FIELD CHANGE ORDER

Number DEQNA-R001

Applicability: Any Micro-PDP11 or Micro-VAX LSI-Bus systems which are attached to Ethernet using the DEQNA at revision level "D" or earlier will need the "Required" FCO. Replace all M7504 (DEQNA) modules below Rev "E1/E2" with reworked devices. Purge all units from the shelf stock in the Field Logistics Stockrooms and SR# 17 which have not been ECO'ed (M7504-MK005) and return for rework to rev "E1/E2." This FCO implements ECO M7504-MK005.

Problem/Symptoms: Undetected Data Corruptions can occur and/or a device "lock-up" can be seen when the DEQNA is busy with a transmit pre-fill operation and a receive message comes in. The DEQNA will appear to be hung and requires a device or system reset to clear the "lock-up."

PICTORIAL REPRESENTATIONS  
OF MODIFIED DEQNA  
- M7504 -

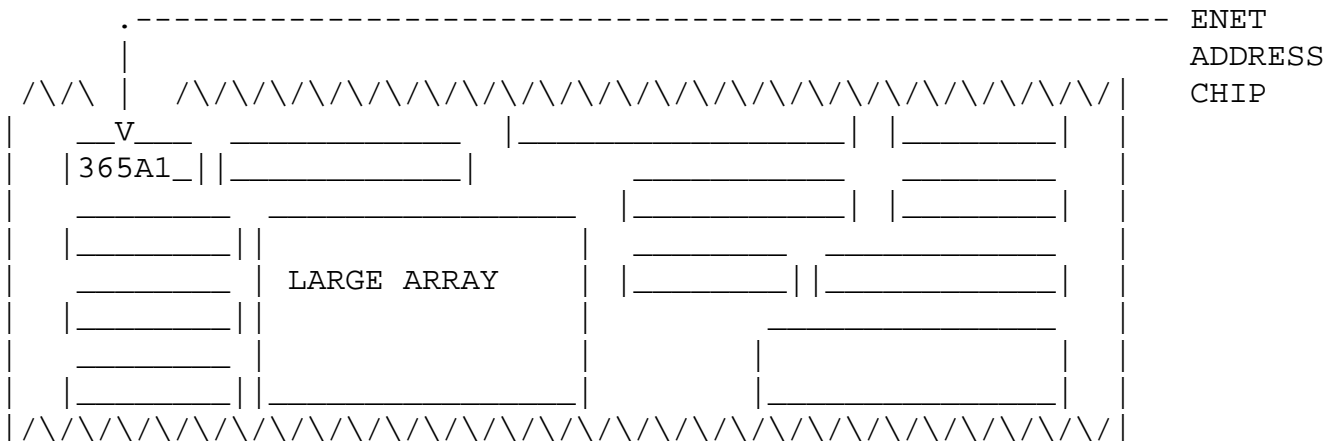
THIS PICTORIAL IS DESIGNED TO AID IN EASY DETECTION OF A REV. E1 OR HIGHER DEQNA UPGRADED MODULE (M7504). THE MODULE REVISION IS STAMPED ON THE BOTTOM OF THE PLASTIC HANDLE VISIBLE ON SIDE TWO (BOTTOM SIDE) AS REFERENCED BELOW. ADDITIONALLY, IF YOUR APPLICATION SOFTWARE IS DEPENDENT UPON THE DEQNA M7504 PHYSICAL ETHERNET ADDRESS, IT MAY BE NECESSARY TO EXCHANGE THE CHIP ON THE "OLD" MODULE WITH THE CHIP ON THE "NEW" MODULE. THE SOCKETED CHIP IS LABELED AS "ENET ADDR" (365A1) AS IDENTIFIED IN THE SECOND PICTORIAL.

PICTORIAL REPRESENTATION  
OF MODIFIED DEQNA  
- M7504 -

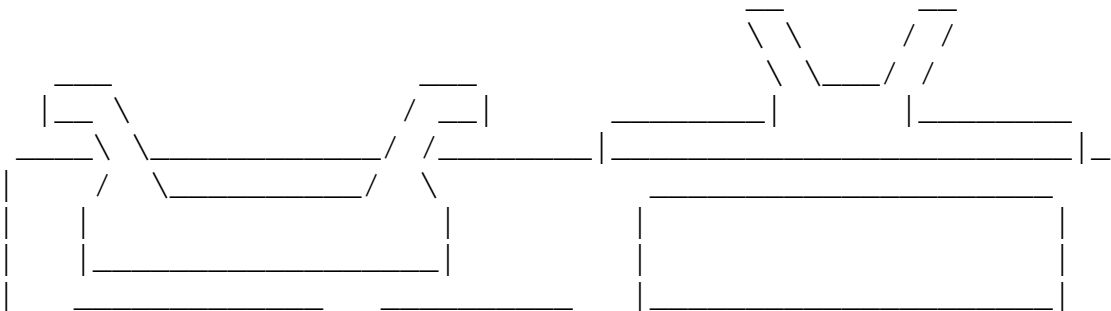
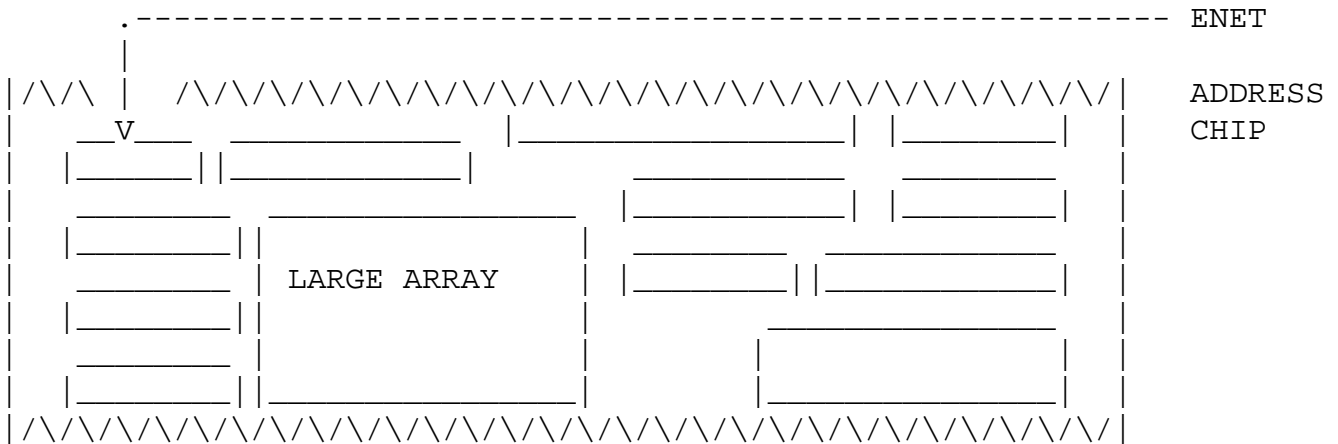
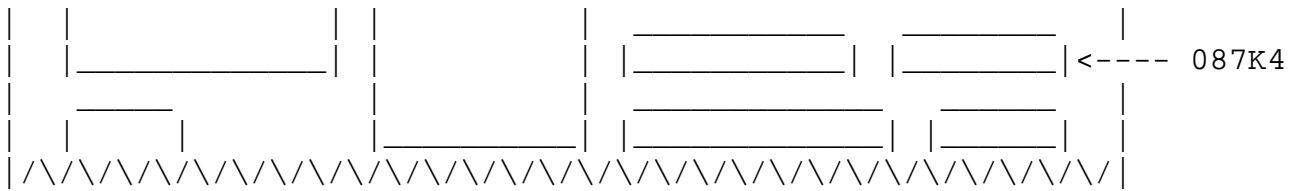
5. Assure that all applicable jumpers and switches on the new M7504 are configured in the same manner as the module being removed. BE SURE TO EXCHANGE THE ADDRESS ROM IN LOCATION E42 (THE 16 PIN DIP, AS SHOWN ON THE NEXT PAGE) FROM THE OLD MODULE TO THE NEW MODULE TO GUARANTEE THE DEQNA ADDRESS REMAINS THE SAME (this will assure that software being down-line-loaded is still addressing the correct node address).

THIS PICTORIAL IS DESIGNED TO AID IN EASY DETECTION OF A REV E1 OR E2 DEQNA REWORKED MODULE (M7504). THE IDENTIFYING FEATURE WHICH WILL ALLOW EASY DETECTION OF THE E1 OR E2 M7504 MODULE IS THE 087K4 LABELED COMPONENT IN THE UPPER RIGHT HAND CORNER OF THE MODULE AS SHOWN BELOW. ADDITIONALLY, IF YOUR APPLICATION SOFTWARE IS DEPENDENT ON THE DEQNA M7504 PHYSICAL ETHERNET ADDRESS, IT MAY BE NECESSARY TO EXCHANGE THE CHIP ON THE "OLD" MODULE WITH THE CHIP ON THE "NEW" MODULE. THE CHIP IS CLEARLY LABELED AS "ENET ADDR" AND IS IDENTIFIED IN THE SECOND PICTORIAL.
